REQUEST FOR TECHNICAL REVISION (TR) COVER SHEET

M-1980-110

Henderson Development (Sandy Acres)

To: Derek Slack, P.E. and Neil Thomson, P.E.
E-470 Public Highway Authority (E-470)
From: Timothy A. Crawford
Subject: E-470 – Sandy Acres Pit – Ponding Water Mitigation Efforts
Job: 9607.00
Date: October 21, 2021

Figure 1
E-470
Sandy Acres Pit
Monitoring Well Locations

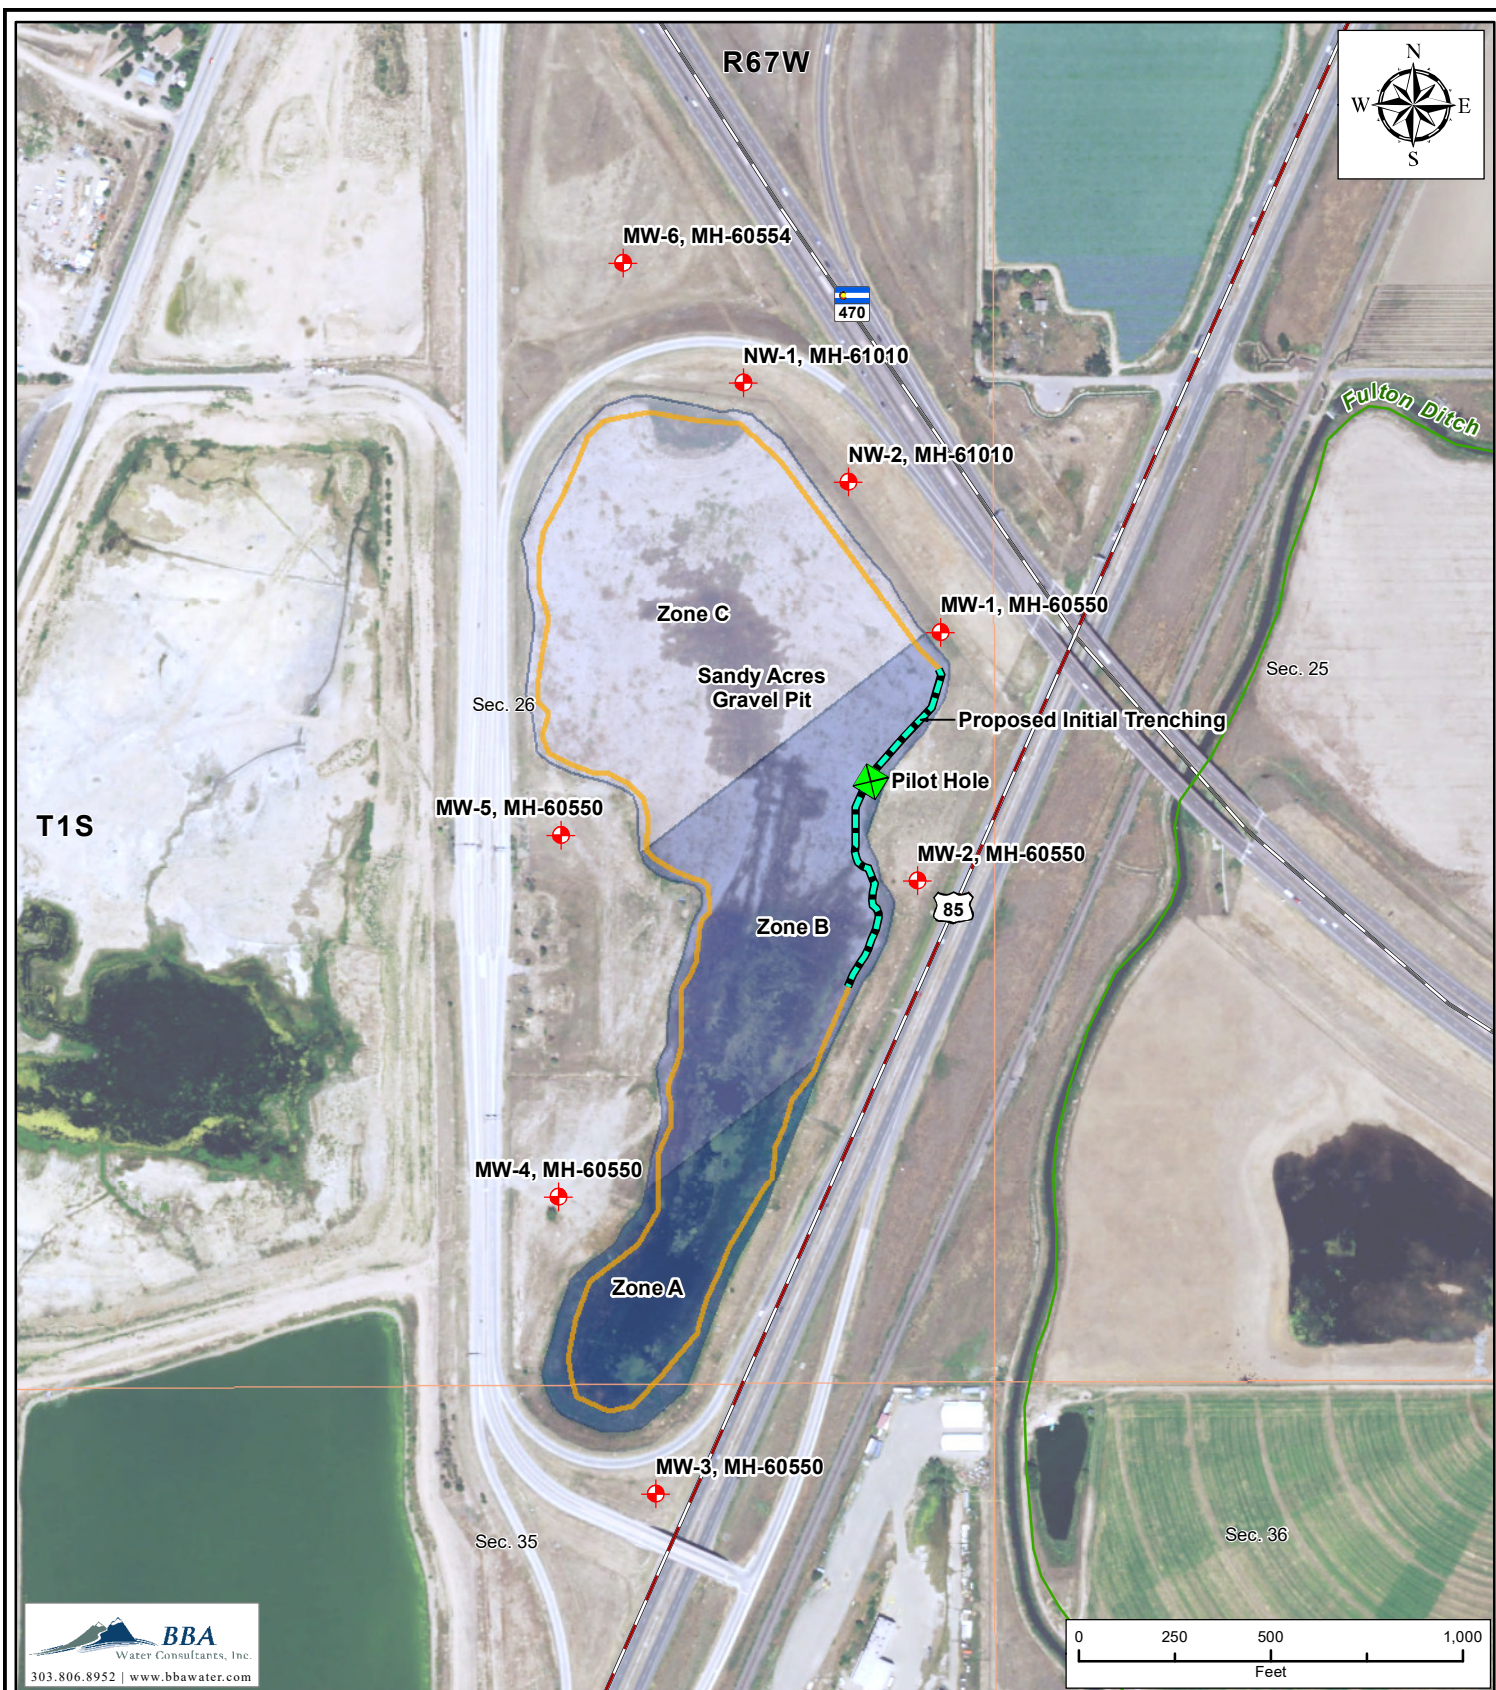
Figure 2 presents 3 perimeter zones around the Sandy Acres Pit representing reaches of the pit perimeter that have differing pit inflow conditions. In “Zone A”, the water level data indicate that ground water inflow to the pit occurs year-round. In “Zone B”, the water level data indicate that

water level conditions vary and ground water inflow to the pit occurs at some times of the year. In “Zone C”, the water level data indicate that no ground water inflow occurs at any time of the year.

to 3 feet, the trenching should be extended upgradient (to the south) until ground water inflow is encountered and continued to the south to induce ground water inflow to be captured by the trench. A minimum 300 feet of additional trenching upgradient should be planned for and additional trenching may be necessary based on ground water conditions. If the initial trenching is saturated at 3 feet, the trenching should be extended down gradient (to the north) to provide for conveyance and discharge of captured inflow. The trenching would then be expanded based on field observations. Initial trenching of up to 500 to 1000 feet may be required. The recommended location of the initial trenching (both the pilot hole and the general trench area) has been presented in Figure 2.
